IN THE MATTER of application for Resource Consent by South Wairarapa District Council for discharge of treated wastewater from the Martinborough Wastewater Treatment Plant to the Ruamahanga River.

**MARTINBOROUGH WWTP DISCHARGE TO THE RUAMAHNAGA RIVER
JOINT RESPONSE OF DR BRIAN COFFEY AND DR OLIVIER AUSSEIL
TO QUESTIONS RAISED BY THE HEARING PANEL
12 November 2015**

Figure 1: Martinborough WWTP: historical and current monitoring and discharge locations.

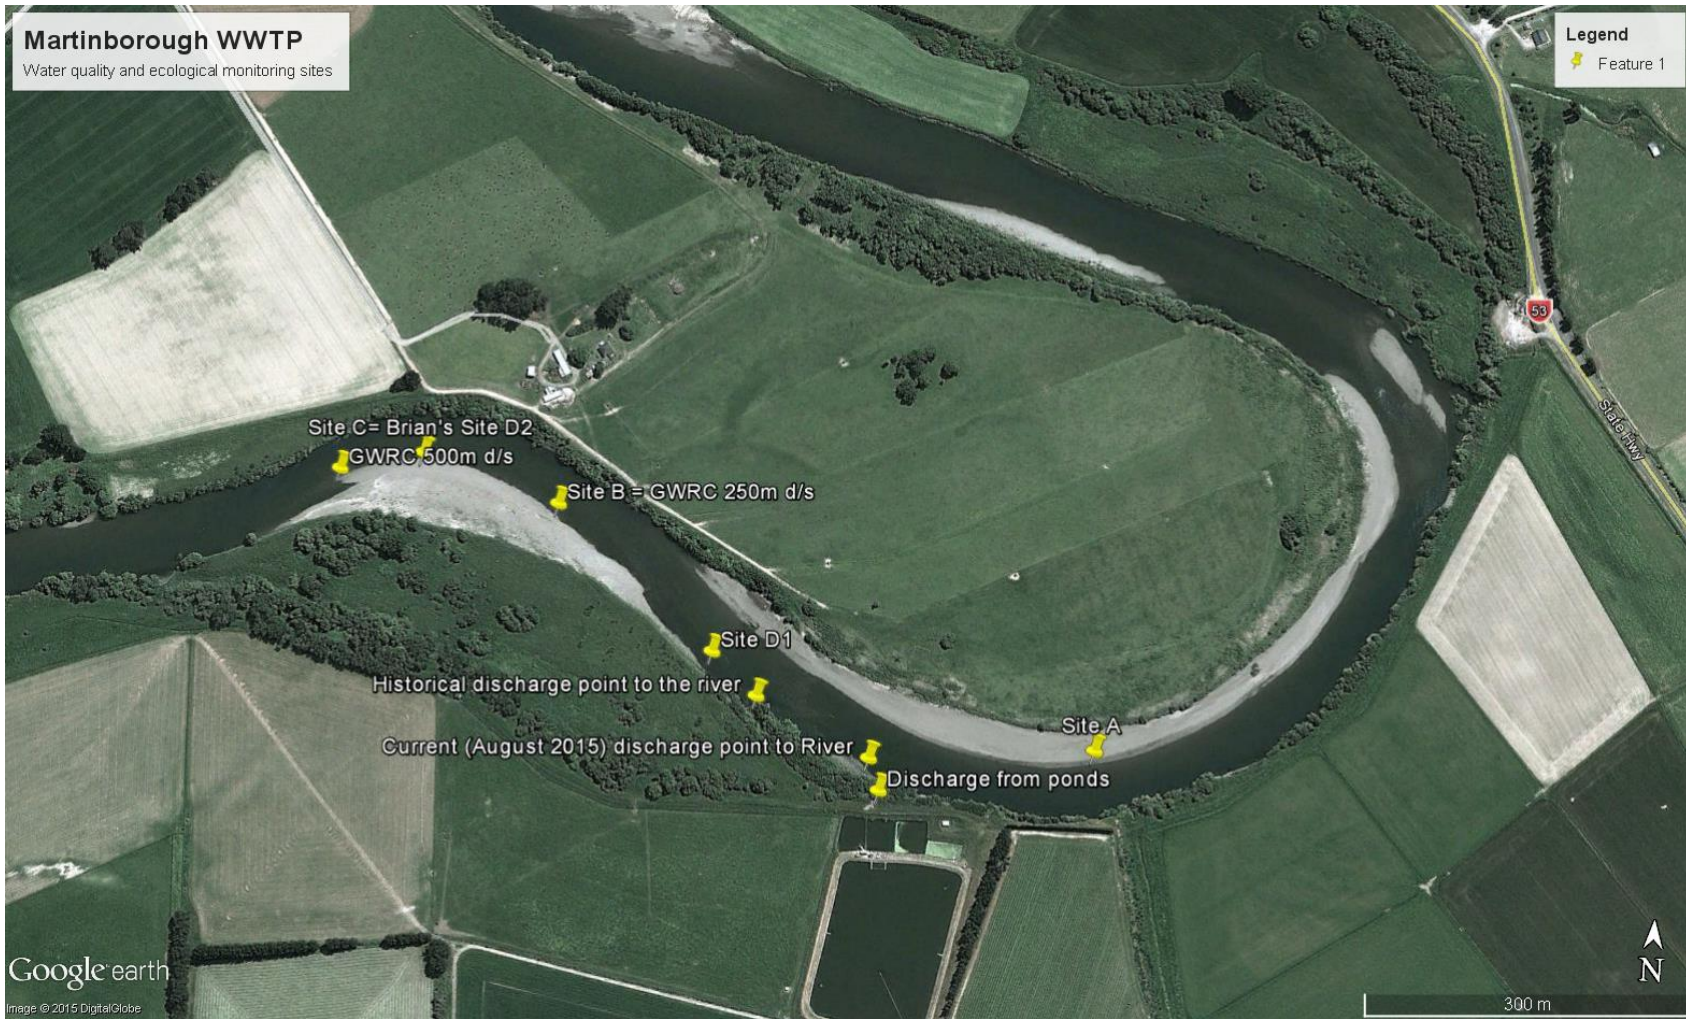
- 2.1 Dr Ausseil visited the MWWTP site on 13 August 2015, with Mr Kerry Geange. Due to a combination of other commitments and river flow conditions, the site visit could not be organised before that date. Figure 1 below presents the different monitoring sites and discharge locations as we understand them. From upstream to downstream, the sites are:

- h) Site B is the historical "250 m downstream Martinborough receiving water" water quality monitoring site, as shown on the maps accompanying the draft consent conditions. The distance between this point and the "current (August 2015) discharge point to river" is close to 370 m, but approximately 250m when measured from the "Historical discharge Point to the river"

- j) The furthest downstream monitoring site is GWRC's second water quality monitoring site (500 d/s monitoring site).
- 2.2 It seems evident that Dr Coffey and GWRC have been measuring distances from different points. This discrepancy is likely to have been the cause to some confusion with regards to the zone of reasonable mixing.

- 2.3 Site D1 (the first downstream monitoring site used by Dr Coffey) is only 20-50m downstream of the historical discharge point and c. 150m downstream of the current monitoring point. Given the mixing characteristics of the discharge with the Ruamahanga River water, we agree that reasonable mixing will not have occurred at this point.

- 2.4 We recommend that:
- a) Site D1 be abandoned for future ecological monitoring. This site is well within the mixing zone (i.e. before reasonable mixing has occurred), and should not be used to assess the effects "after reasonable mixing".

- c) The upstream monitoring site should be at site A, as shown on Figure 1
 - d) The first downstream site should be at Site B as shown on Figure 1;
 - e) The second downstream monitoring site should be at the GWRC 500m downstream site. Monitoring at this site may be able to be discontinued after an initial period (3 years) if the absence of significant adverse effects at the first downstream site is confirmed.

- 2.5 We recommend that SWDC maintain the existing (as of August 2015) discharge channel and discharge location to the Ruamahanga River. Based on the site visit, Dr Ausseil considers that only very minor works will be required. Regular inspection and maintenance of the discharge channel is recommended, and such requirement may need to be included in the consent conditions.

Figure 2: *Engineered High Flow Back Channel that has recently been constructed downstream of the MWWTP by Greater Wellington Regional Council.*

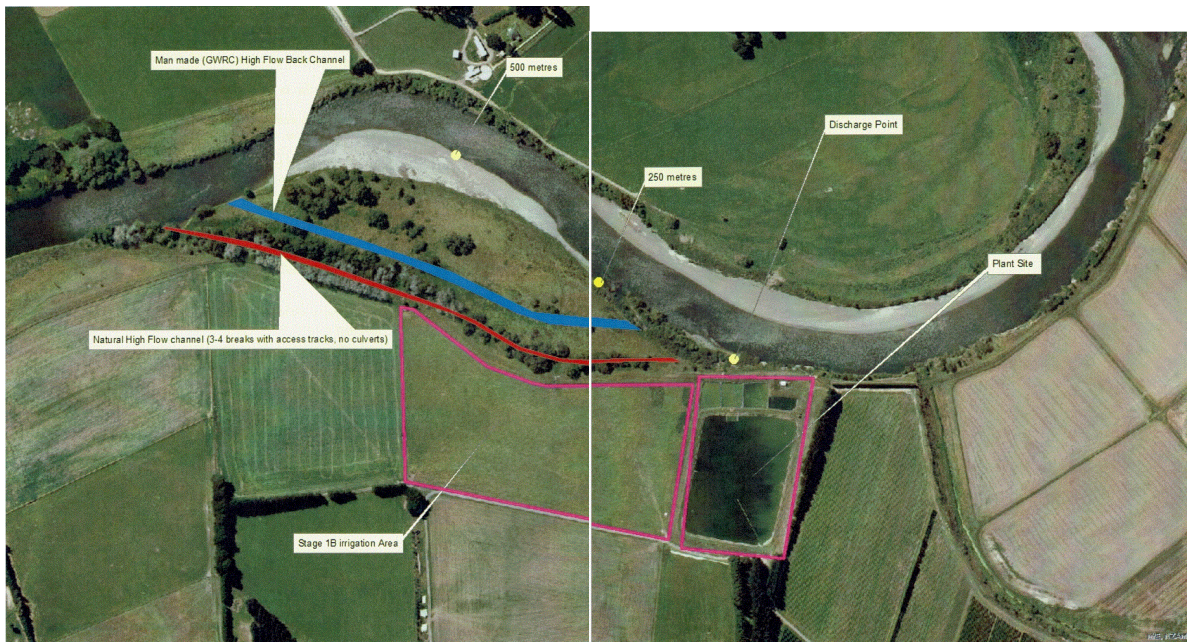
- 3.1 It is understood that, in the current state of the high flow channel, only greater than normal river flows (i.e. $>50 \text{ m}^3/\text{s}$ as measured at Waihenga) will enter the engineered high flow back channel on the left bank of the Ruamahanga River as shown in Figure 2. It is also our understanding that GWRC will not maintain the lip at the entrance of the engineered channel. In other words there is no guarantee that the current situation will remain in the future. We comment in turn on the current situation (i.e. the high flow channel as observed in August, with a lip preventing flows $< 50 \text{ m}^3/\text{s}$ from entering the channel), and the potential implications of changes in the future (i.e. if the lip is eroded and allows lower river flows to enter the channel).

- 3.3 Under the current situation, a proportion of any discharge from the MWWTP to the Ruamahanga River that occurs at river flows in excess of 50 cumecs may be entrained in the engineered high flow back channel and enter the Ruamahanga River downstream of the 500 m site shown in Figure A. Indeed, given the locality of the intake for the engineered high flow back channel, most of the discharge from the MWWTP to the Ruamahanga River that occurs at river flows in excess of 50 cumecs would be expected to enter the engineered high flow back channel and discharge to the Ruamahanga River downstream of the 500 m site shown in Figure A.

- 3.4 However, we consider that, during Stages 1B and Stage 2A, the discharges to the river most at risk of causing ecological effects are those that will occur at river flows between half median flow and $50 \text{ m}^3/\text{s}$. By contrast, discharges to the river at river flows $>50 \text{ m}^3/\text{s}$ are highly unlikely to cause significant adverse effects on water quality or ecology.

- 3.5 On this basis, under the current high flow channel configuration, the monitoring sites recommended above are considered appropriate, and no changes are recommended as a result of the high flow channel (assuming that the high flow channel only operates at flows $>50 \text{ m}^3/\text{s}$).

- 3.6 We now consider the scenario under which the lip of the high flow channel is eroded and allows flows significantly lower than $50 \text{ m}^3/\text{s}$ to enter the channel.

- 3.7 We recommend that the configuration of the entrance to the high flow channel be monitored during Stage 1A and during stage 1B. If this changes to a point where flows close to half median

flows are able to enter the channel, then the adequacy of the existing monitoring sites should be reviewed by a suitably qualified expert.
